**PARKWEST CASINO 580 EXPANSION PROJECT**  
**RESPONSES TO PUBLIC COMMENTS ON THE INITIAL STUDY/MITIGATED**  
**NEGATIVE DECLARATION**

**Re: Parkwest Casino 580 Expansion Project – Mitigated Negative Declaration (MND)**

Figure 1  
Site Plan

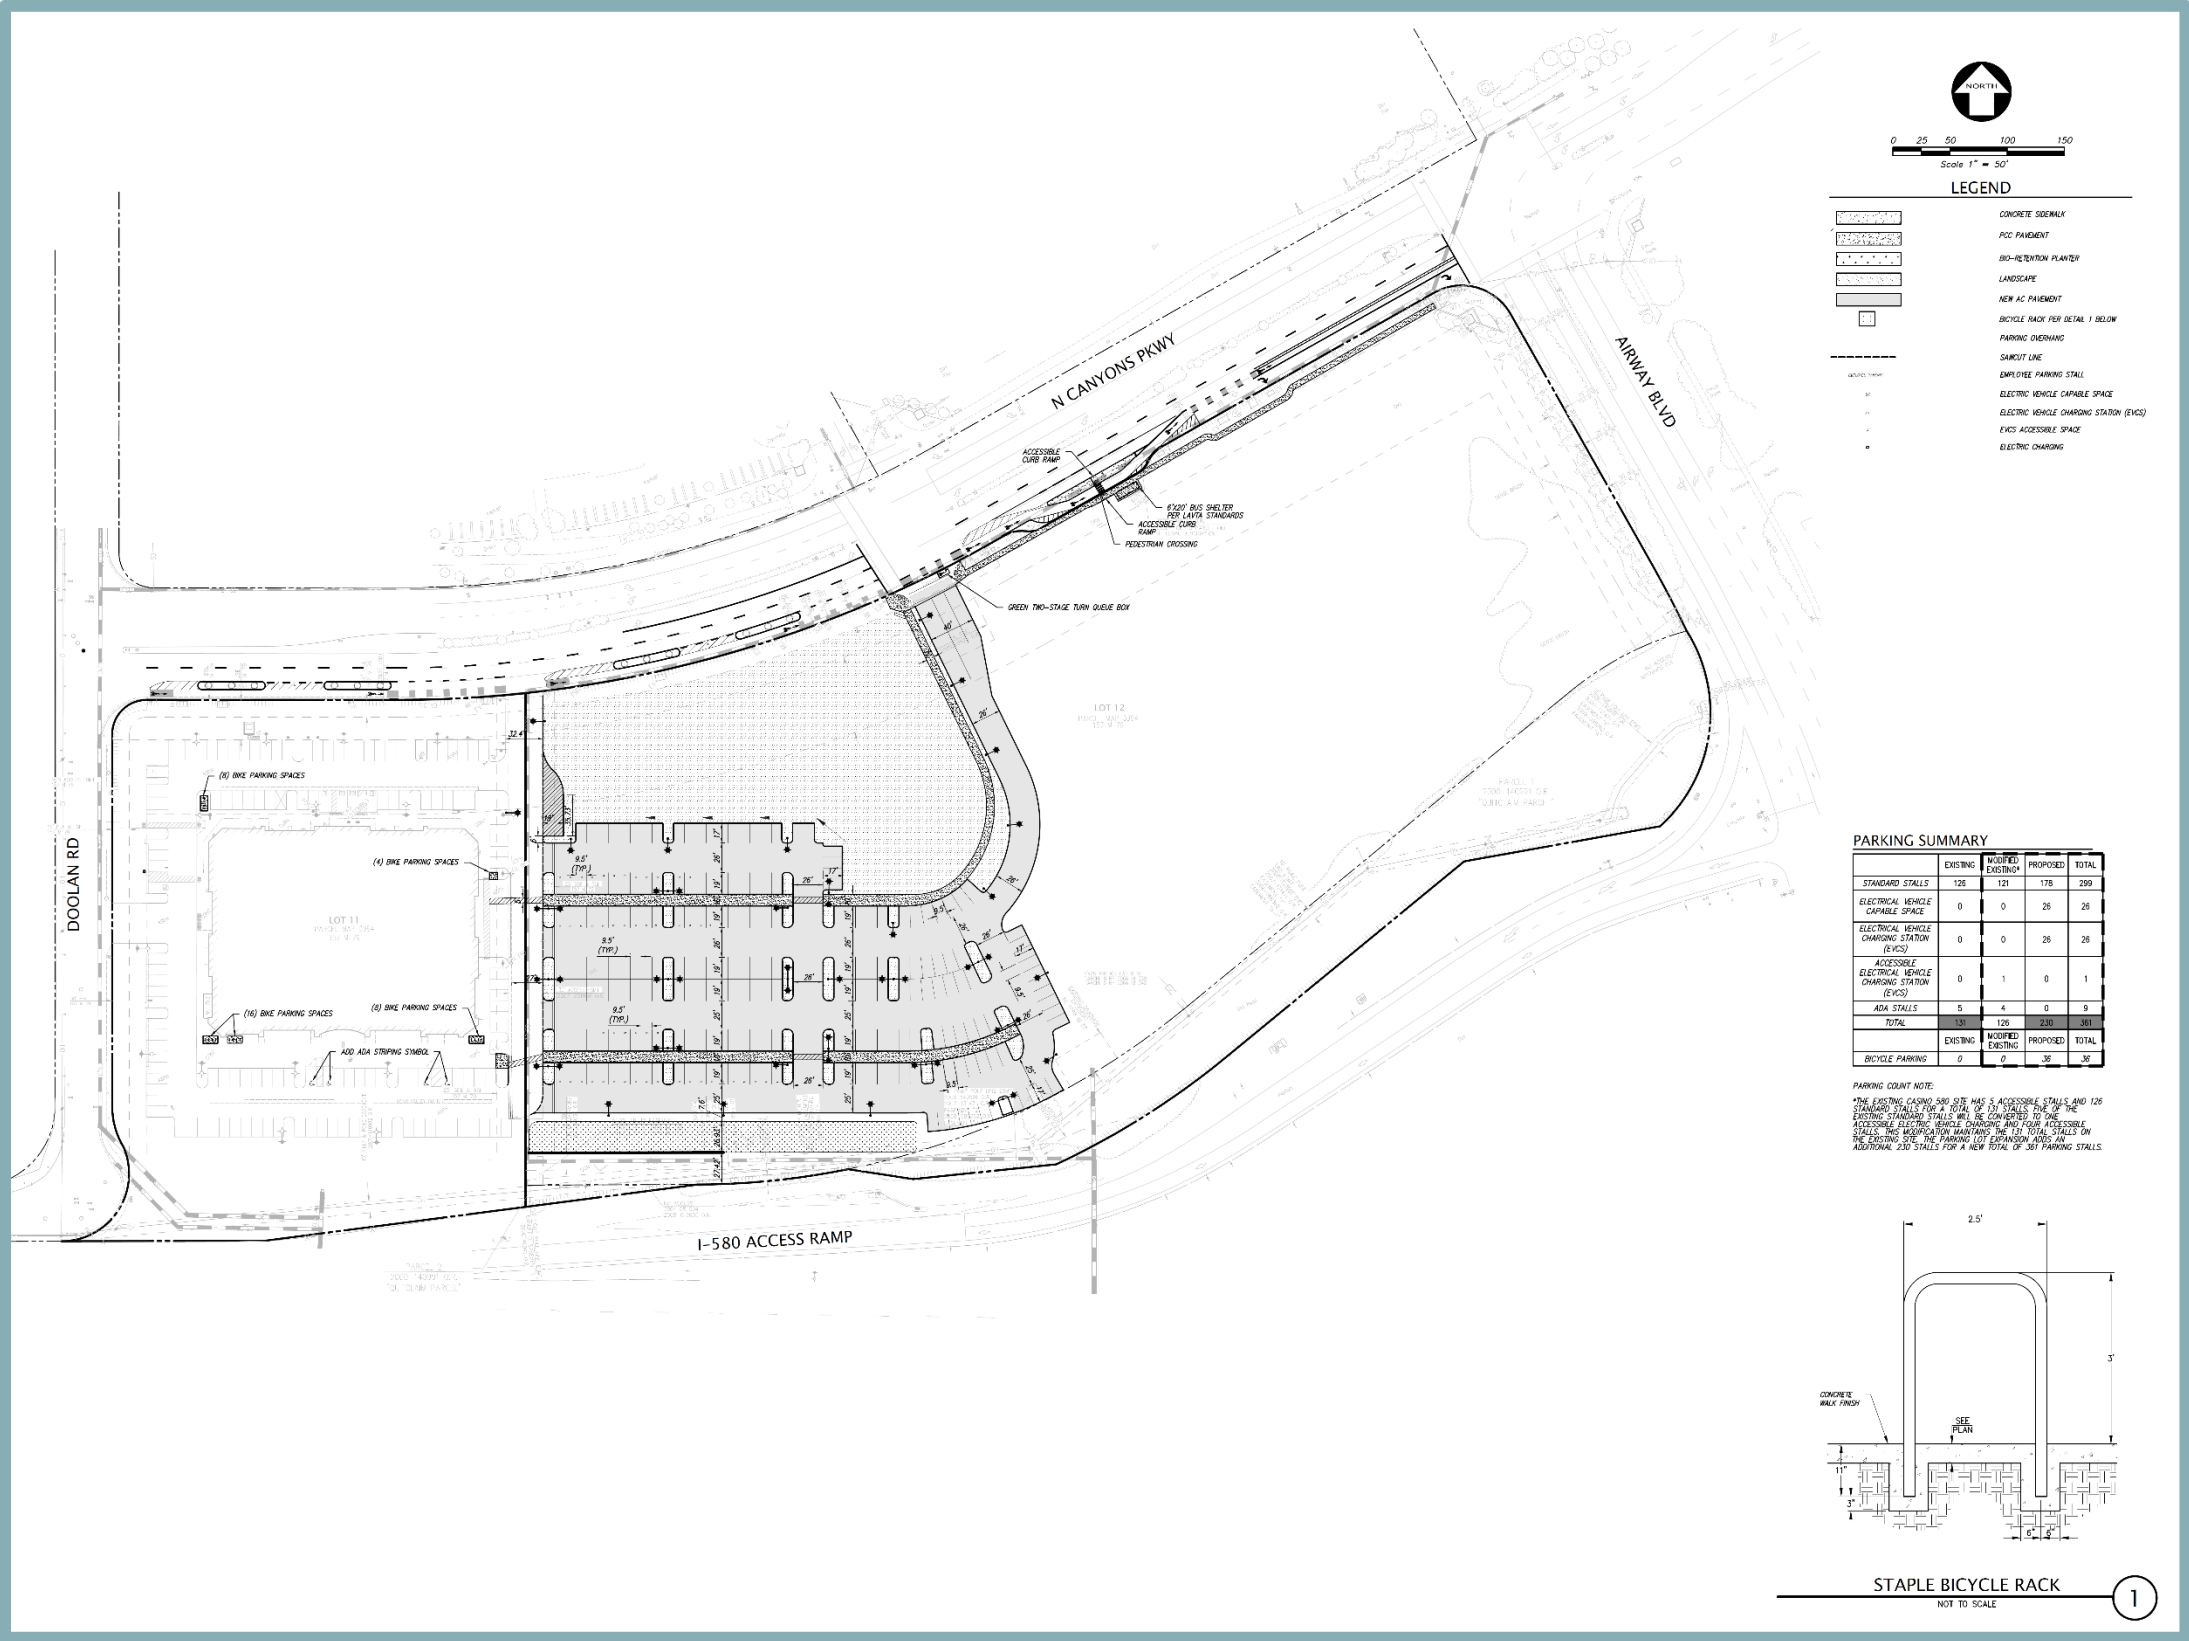
Please provide the flow rate at the outfall of the bio-treatment planters (Outfall Q) and clarify where the bio-treatment planters outfall to, as there are concerns that the outfall may tie to the State Drainage System.. If the bio-treatment planters are tied to a State drain, further mitigation measures may be needed. Please see the attachment at the end of this letter for known drainage facilities in the area.

In response to the comment, the project applicant has modified project plans to avoid all California Department of Transportation (Caltrans) right-of-way, easements, and infrastructure. The layout of the proposed project has shifted slightly, but the number of parking stalls would remain unchanged. The proposed project's storm drain infrastructure would connect to the City's existing storm drain that travels through the project site. Therefore, Figure 3 and Figure 4 of the IS/MND have been replaced with those shown at the end of this document.

Stormwater runoff from the new impervious surfaces within the DMAs would be directed to the ~~three~~ on-site bioretention planters, ~~with two located within DMA 1 as part of Treatment Control Measure (TCM) 1, and one located within DMA 2 as part of TCM 2.~~ (see Figure 4).

Storm water runoff within the project site would flow to ~~three~~ a bioretention planters located in the proposed parking lot that would provide treatment and retention of the on-site stormwater runoff. As shown above in Figure 4, the total treatment area on-site would be equal to new impervious area plus 10 percent of the landscaped area, as required by the County C.3 Stormwater Standards. Thus, adequate storage would be provided on-site.
